SITING AND GRADING PLAN

Royal Pine Homes / Centerfield Properties Inc - 216102  
"OAKRIDGE MEADOWS", RICHMOND HILL, ON

Lot / Page Number  
BLOCK 57

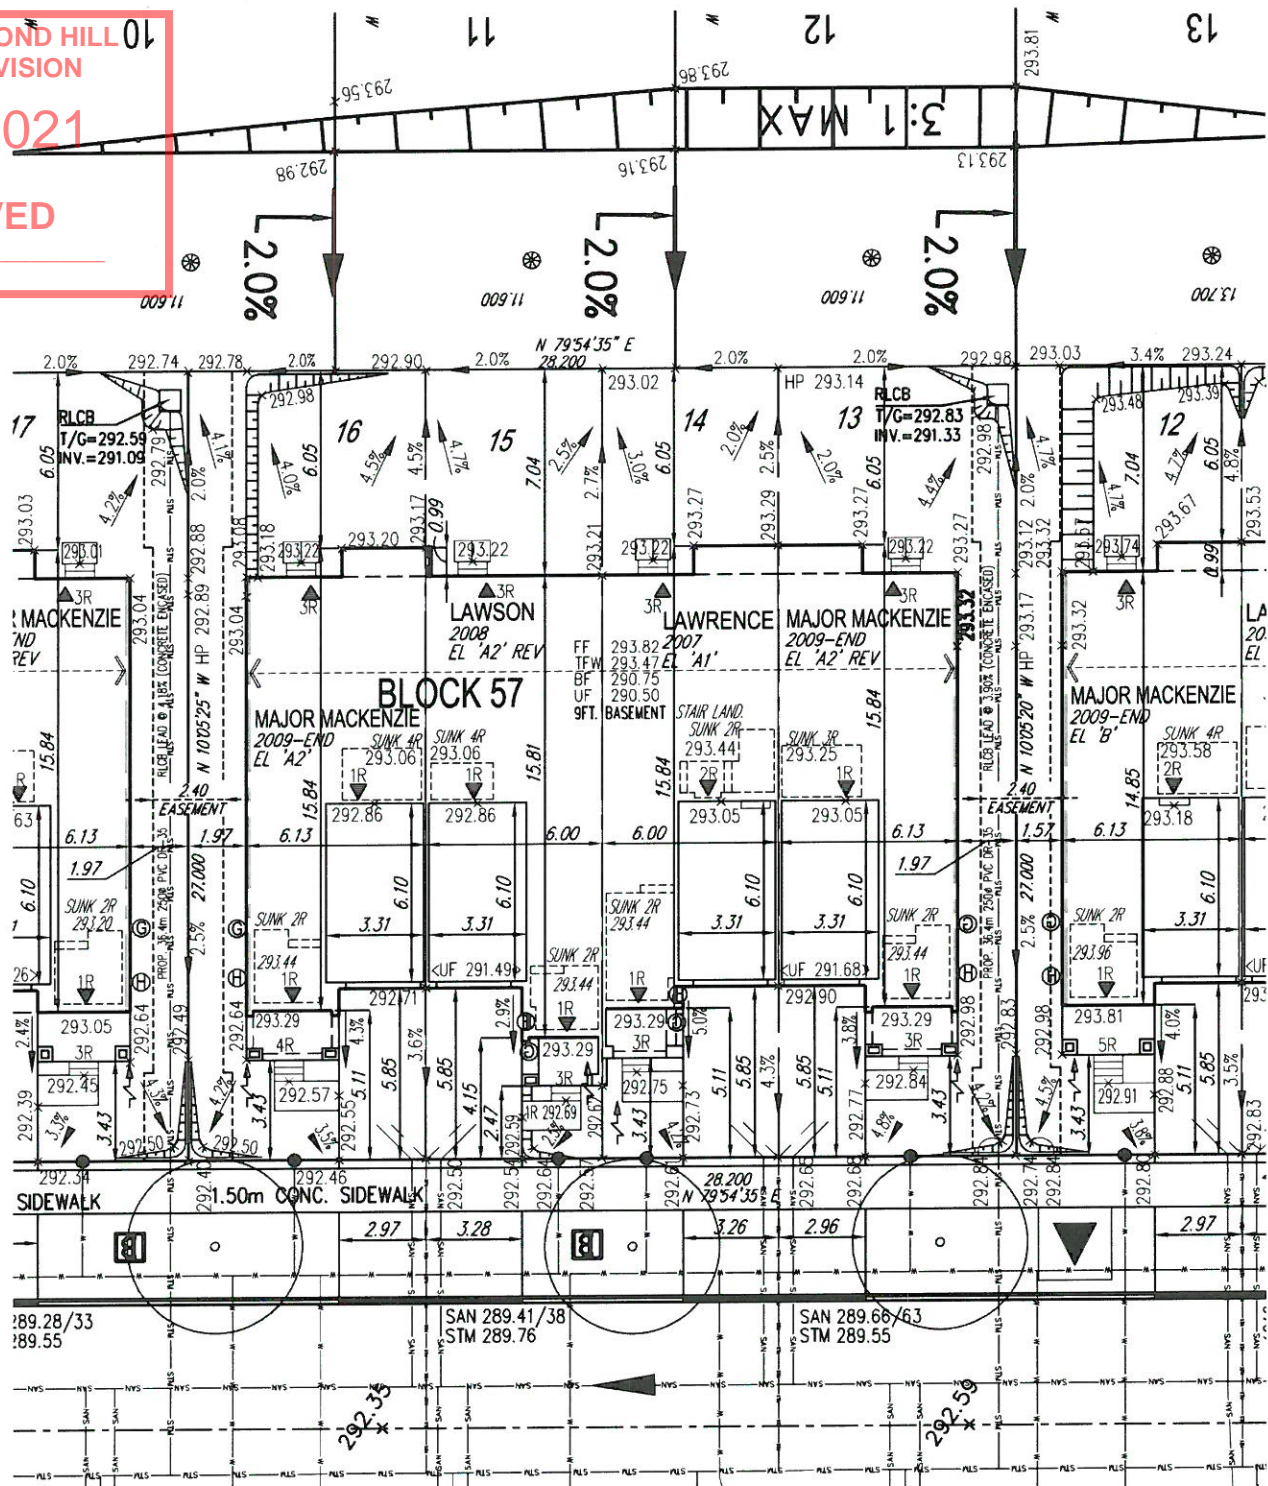
As per OBC 2012, Div.B, 9.10.14.5(5), projections such as balconies, eaves, stairs, etc., that are more than 1m above grade, shall be non-combustible when within 1.2m of a property line or 2.4m of a combustible projection on another building on the same property.

No unprotected openings permitted within 1.2 meters of the lot line as per article 9.10.14 of the Ontario Building Code.
